DWIGHT D. EISENHOWER

SECTION 106 MOA ANNUAL UPDATE 2014

DESIGN REVISION
2014 MOA UPDATE

CONCEPT DESIGN RE-SUBMISSION

PLAN-DIAGRAM

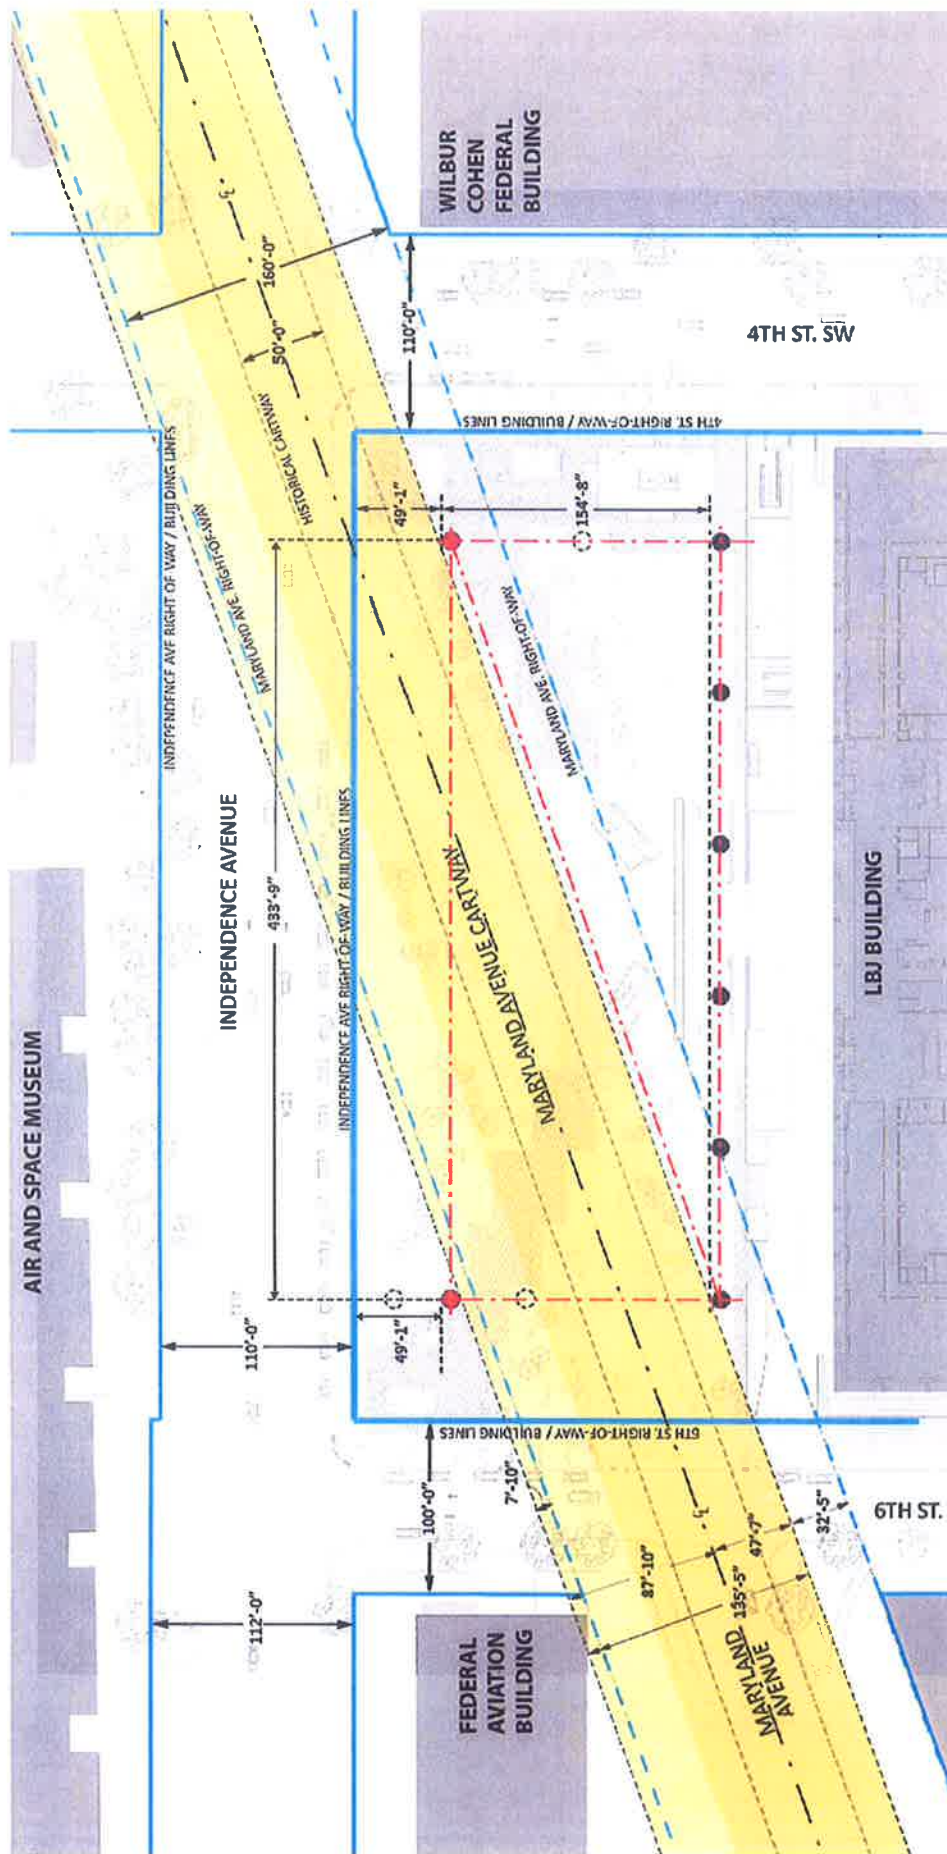
- The northern singular columns to be located fully within the planes of the adjacent building facades.

- The design revisions widen the Maryland Avenue viewshed from 95' to 135' wide creating a proportionally *horizontal* framed view towards the Capitol building.
- 2013 MOA Update concept included three columns that were within the 160' ROW. The revised plan includes only two columns within the southern edge of the ROW.
- The southwest column and northeast column align parallel to the center line of Maryland Avenue.

VIEW ALONG MARYLAND AVENUE TOWARDS CAPITOL

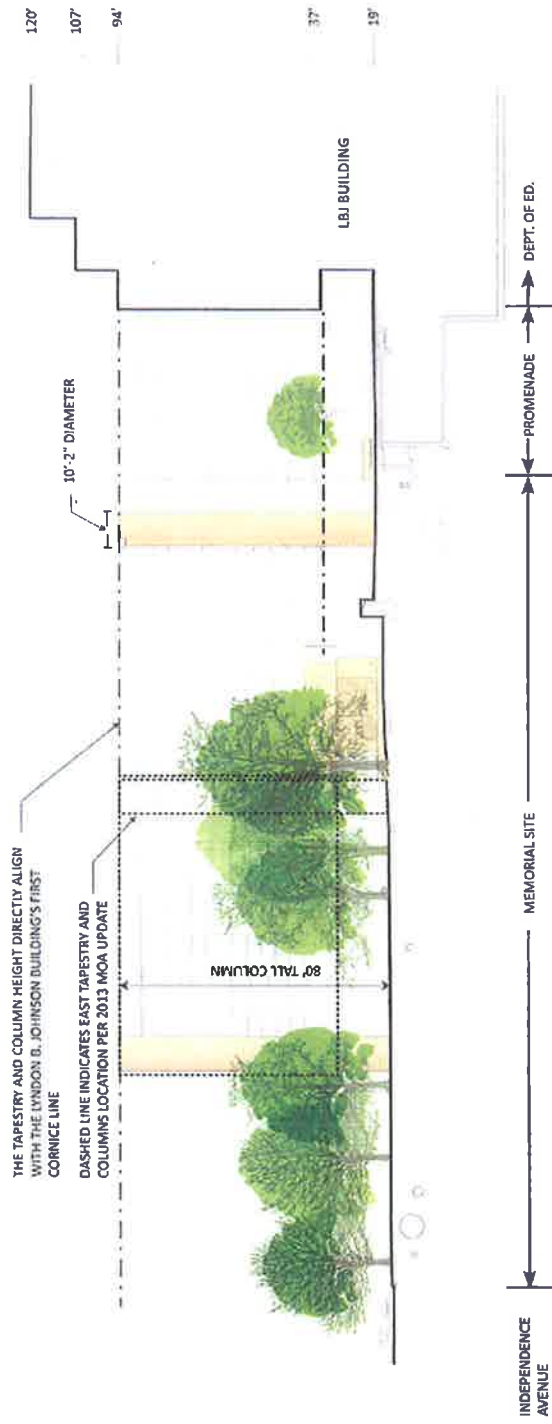
VIEW ALONG MARYLAND AVENUE TOWARDS CAPITOL - The design revisions widen the Maryland Avenue viewshed from 95' to 135' wide, creating a proportionally *horizontal* frame to the Capitol building.

OCTOBER 2014 - REVISED DESIGN

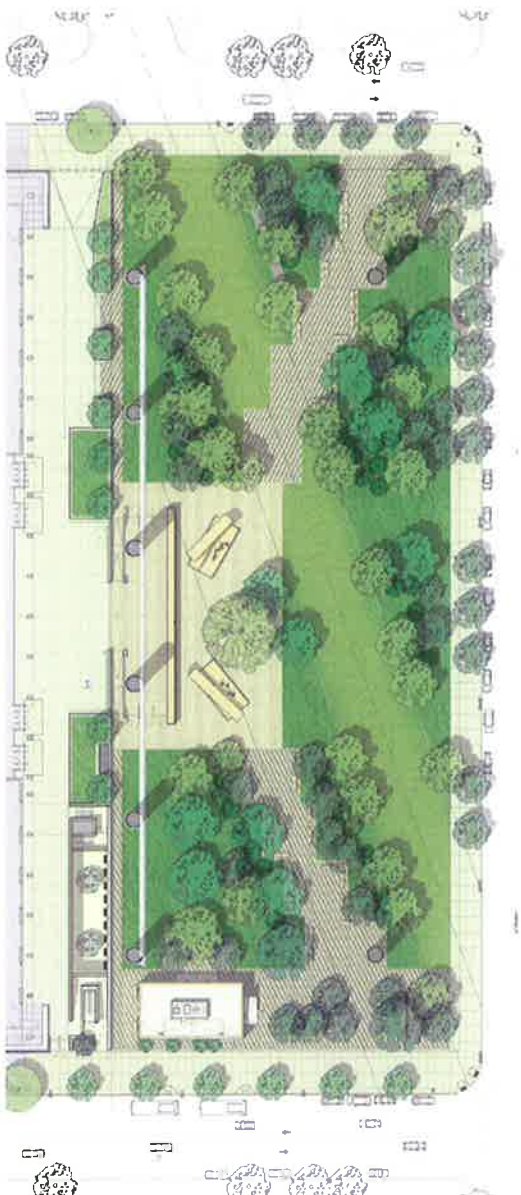
1. The revised design eliminates the East and West tapestries allowing the influence of the adjacent buildings to define and unify the site.
2. Two singular columns replace the East and West tapestries, defining the northern edge of the Memorial site. The proposed northern columns are fully located within the planes of the adjacent building facades.
3. The revised design has widened the view corridor from 95' to 135'. This design revision creates a more proportionally *horizontal* framed view of the U.S. Capitol.
